ROAD  
HANGAR

Job No: 1499  
Revisions:  
Sheet Title: TOPOGRAPHIC MAP  
Date: 7-24-84  
Drawn:  
Sheet No: C 1 of sheets

liberty plaza

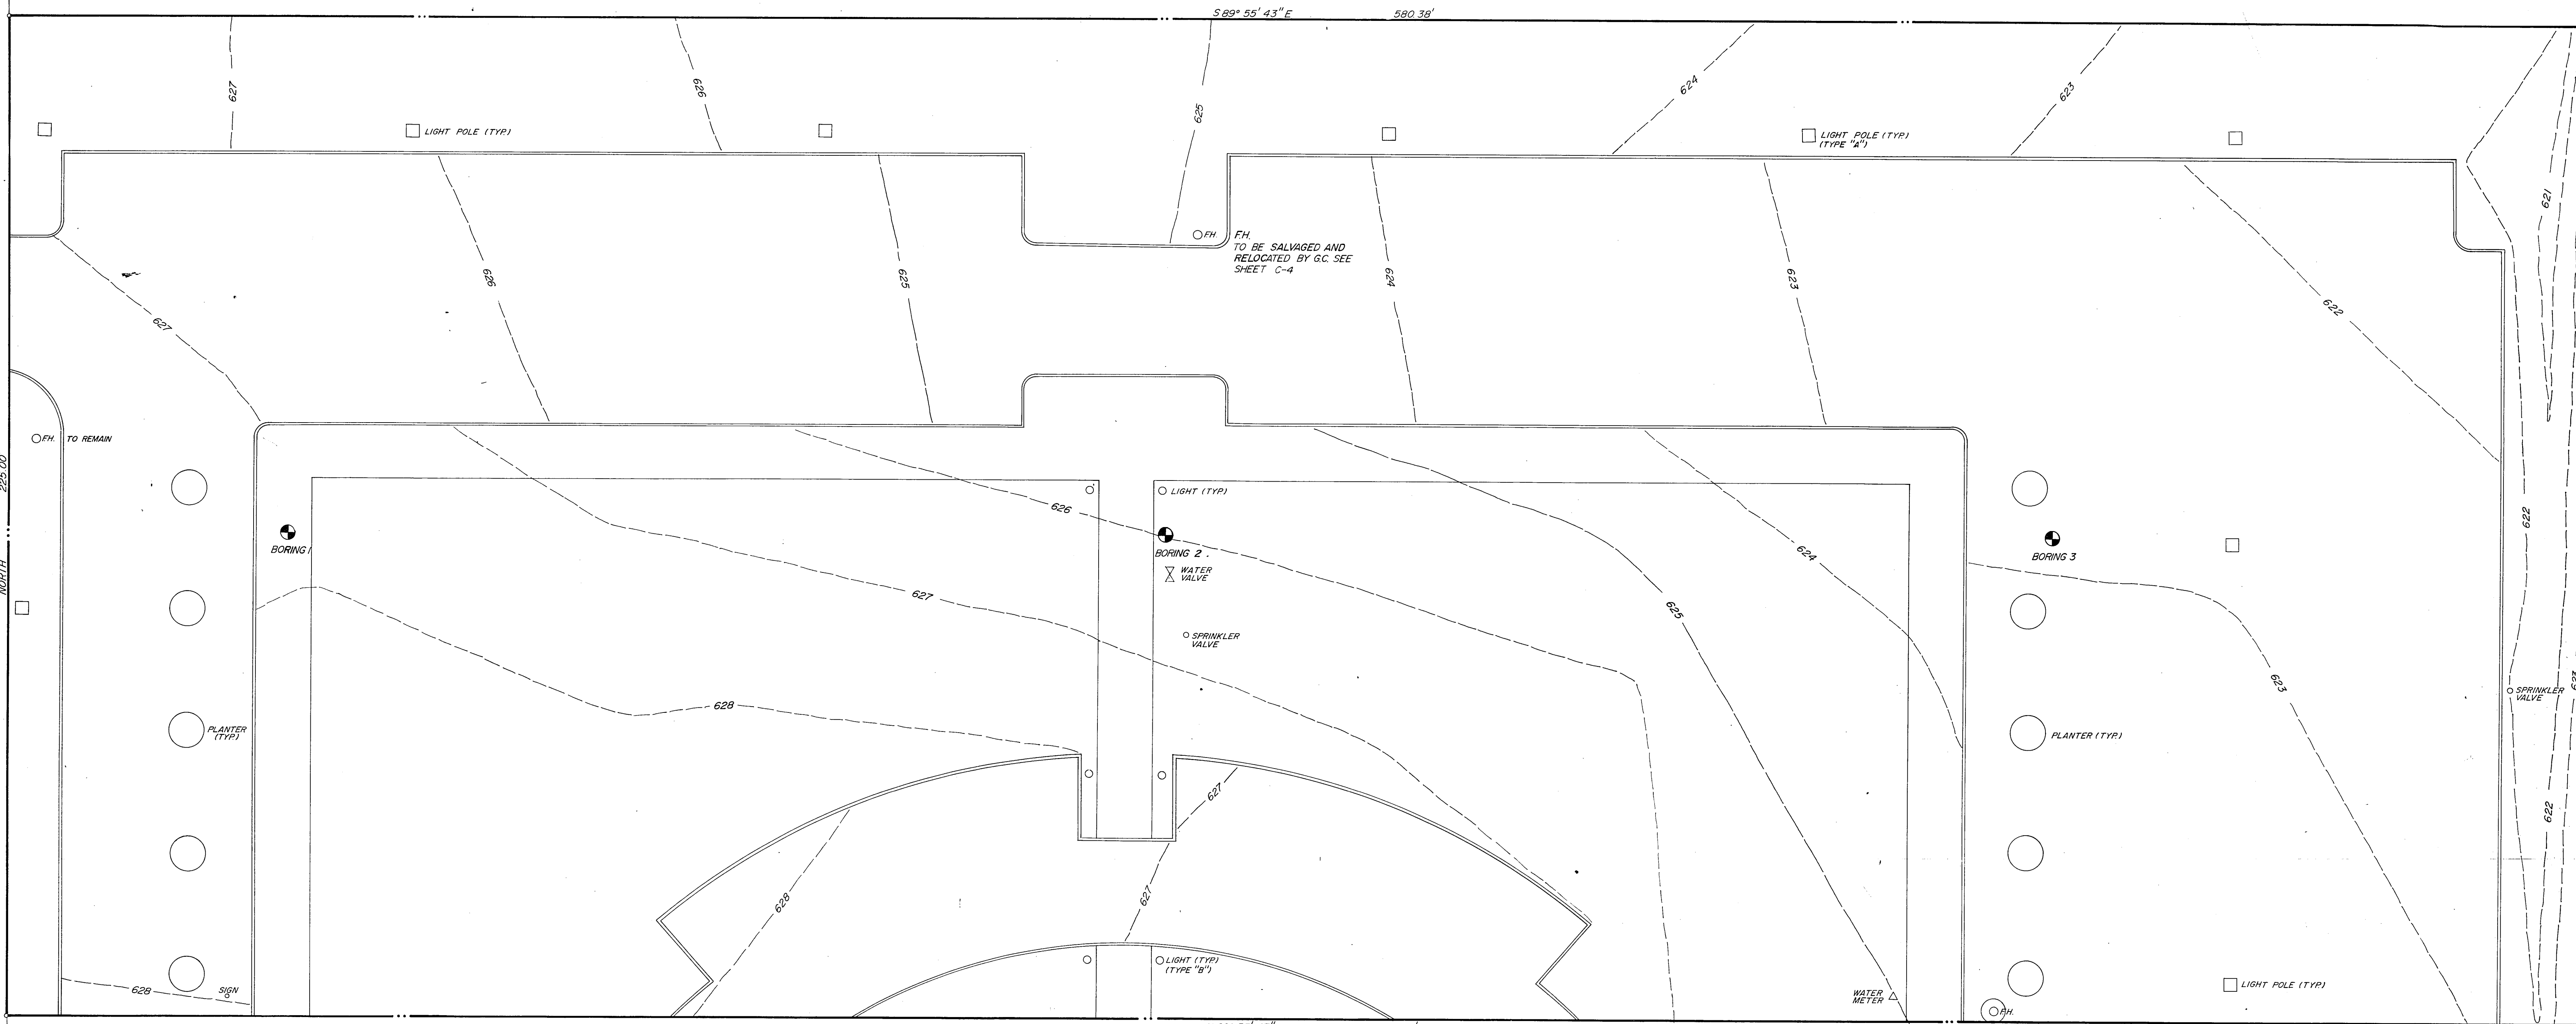
- FIRE EXTINGUISHERS:  
Minimum rating 2A 10BC  
Maximum travel distance 75'  
Minimum one per 6,000 sq ft

- No sprinkler omissions
- Alarm system to be monitored at a constantly attended location
- Fire lanes to be to A.F.D.'s specs (attached)
- Fire hydrants 300' O.C.

See notes C-4 & C-5  
CONDUCT LINA FOR USGMA APPROVAL BEFORE C.O.
